SUBJECT: RELOCATION OF CERTAIN TECHNICAL SPECIFICATIONS TO CORE OPERATING
LIMITS REPORT, LIMERICK GENERATING STATION, UNITS 1 AND 2 (TAC
NOS. M89916 AND M89917)

The Commission has issued the enclosed Amendment No. 77 to Facility Operating License No. NPF-39 and Amendment No. 38 to Facility Operating License No. NPF-85 for the Limerick Generating Station, Units 1 and 2. These amendments consist of changes to the Technical Specifications (TS) in response to your application dated June 30, 1994.

These amendments relocate selected recirculation and control rod block instrumentation setpoints from Technical Specifications (TS) Table 3.3.6-2, and Section 3/4.4.1 to the Core Operating Limits Report (COLR), thereby revising TS Section 6.9.1.9 to document relocation of these items into the COLR. Please inform the staff, in writing, when these amendments have been implemented.

TABLE 3.3.6-2 (continued)

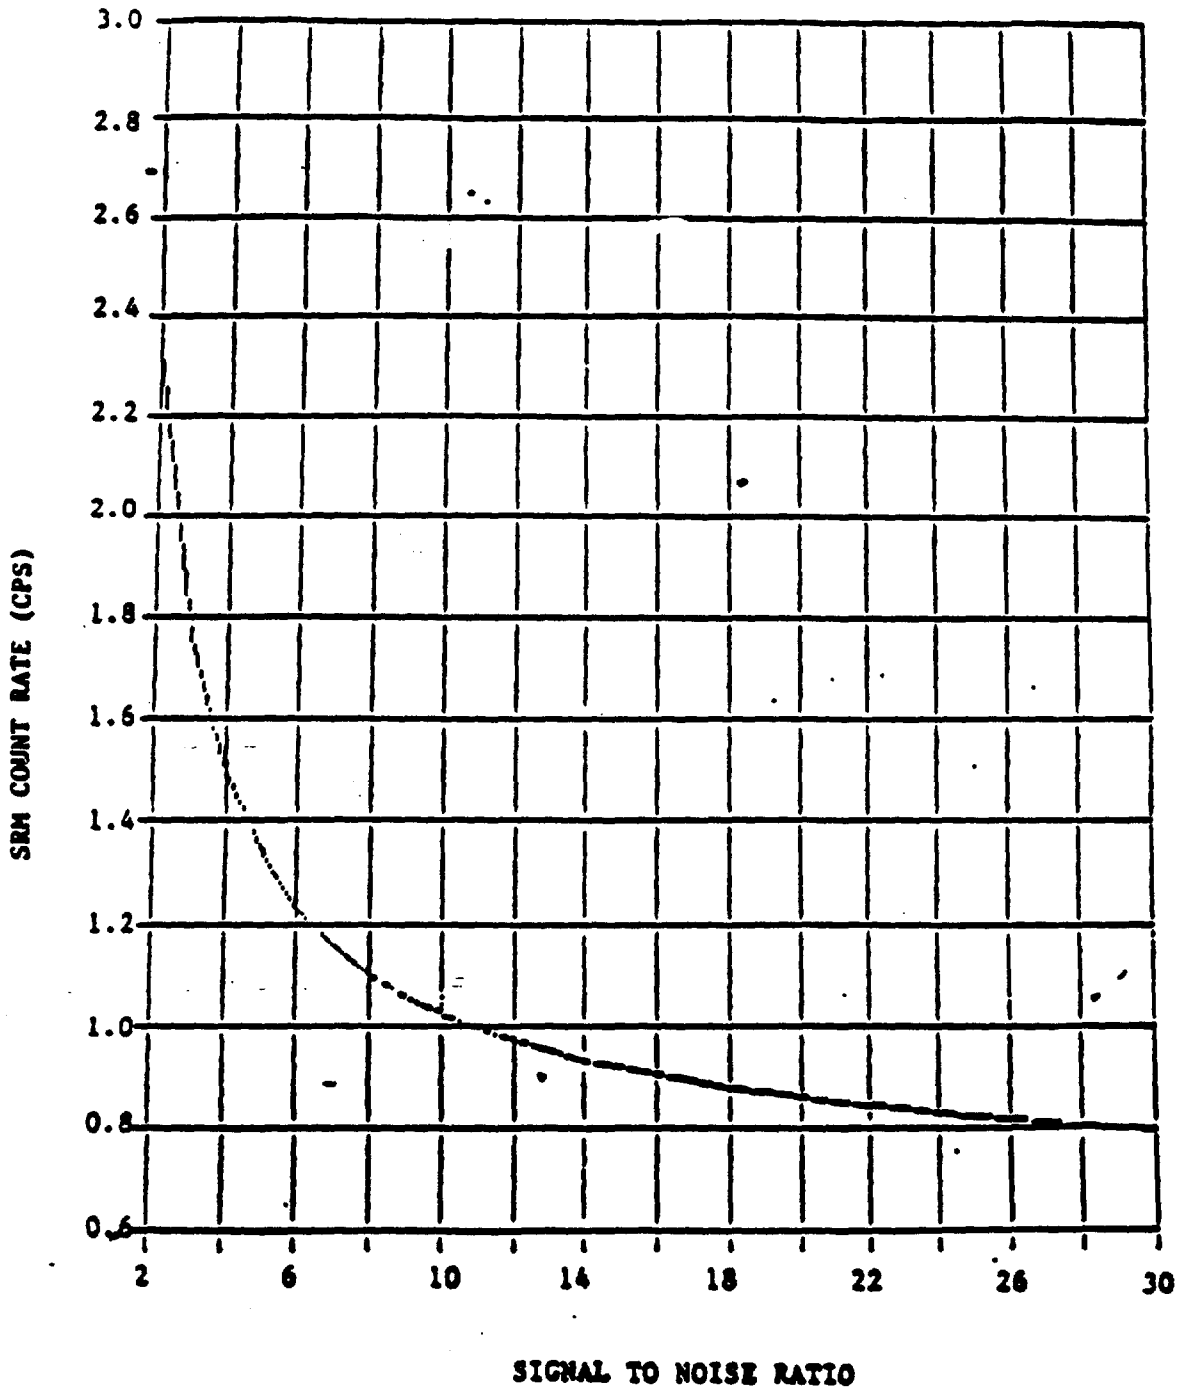
<u>TRIP FUNCTION</u>	<u>TRIP SETPOINT</u>	<u>ALLOWABLE VALUE</u>
6. <u>REACTOR COOLANT SYSTEM RECIRCULATION FLOW</u>		
a. Upscale	*	*
b. Inoperative	N.A.	N.A.
c. Comparator	≤ 10% flow deviation	≤ 11% flow deviation
7. <u>REACTOR MODE SWITCH SHUTDOWN POSITION</u>	N.A.	N.A.

* Refer to the COLR for these setpoints.

TABLE 3.3.6-2 (Continued)

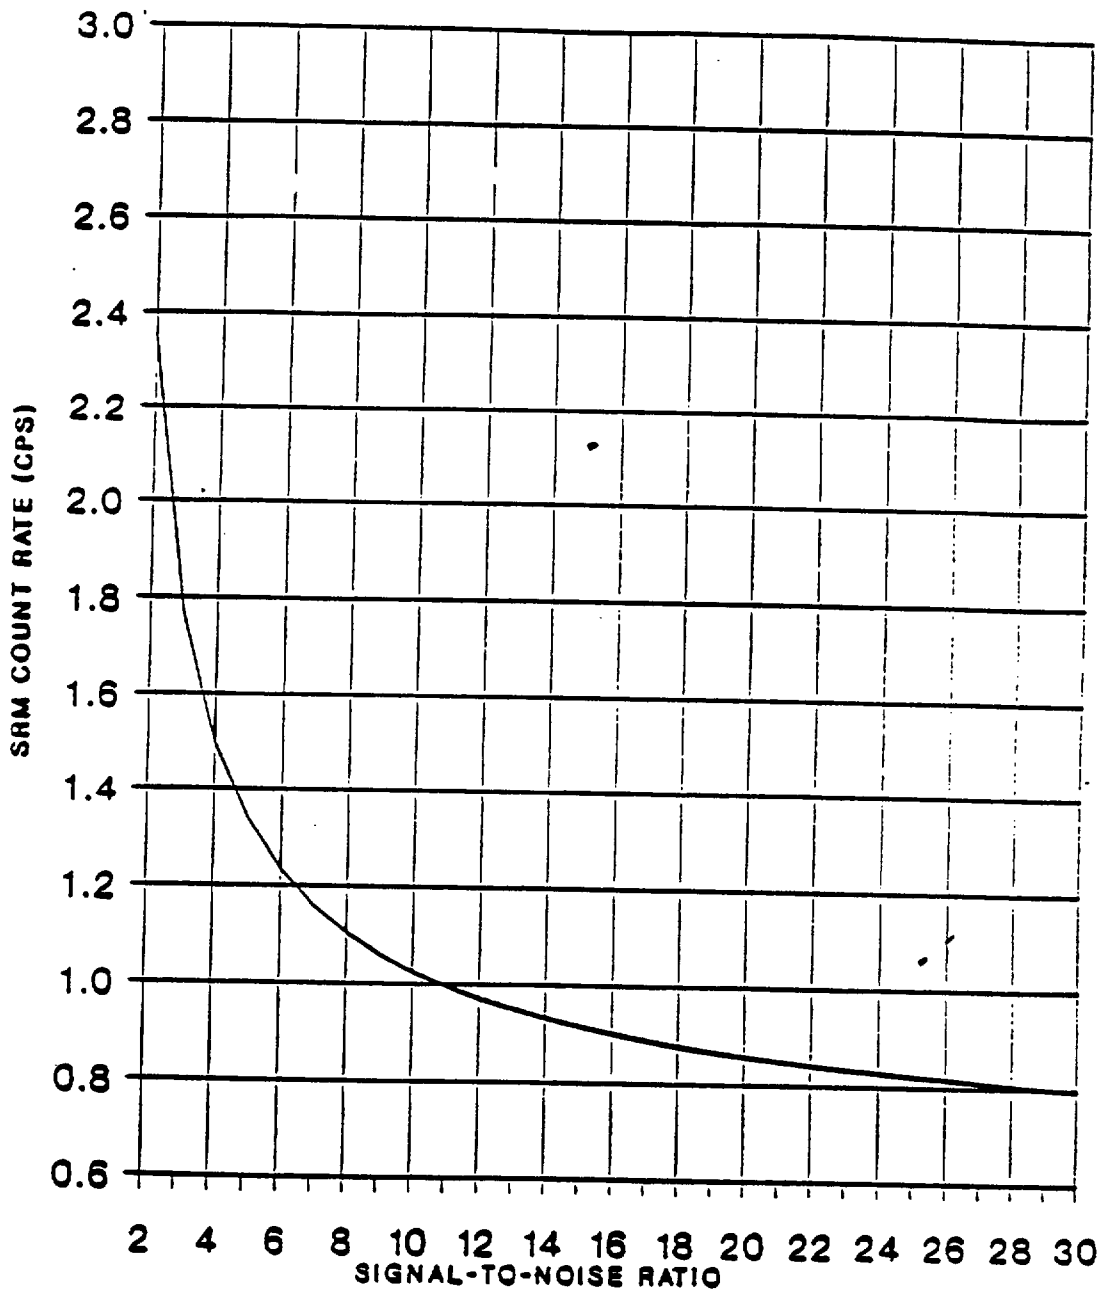
<u>TRIP FUNCTION</u>	<u>TRIP SETPOINT</u>	<u>ALLOWABLE VALUE</u>
4. <u>INTERMEDIATE RANGE MONITORS</u>		
a. Detector not full in Upscale	N.A. ≤ 108/125 divisions of full scale	N.A. ≤ 110/125 divisions of full scale
c. Inoperative	N.A.	N.A.
d. Downscale	≥ 5/125 divisions of full scale	≥ 3/125 divisions of full scale
5. <u>SCRAM DISCHARGE VOLUME</u>		
a. Water Level-High a. Float Switch	≤ 257' 7 3/8" elevation***	≤ 257" 9 3/8" elevation
6. <u>REACTOR COOLANT SYSTEM RECIRCULATION FLOW</u>		
a. Upscale	*****	*****
b. Inoperative	N.A.	N.A.
c. Comparator	≤ 10% flow deviation	≤ 11% flow deviation
7. <u>REACTOR MODE SWITCH SHUTDOWN POSITION</u>	N.A.	N.A.

***** Refer to COLR for these setpoints.
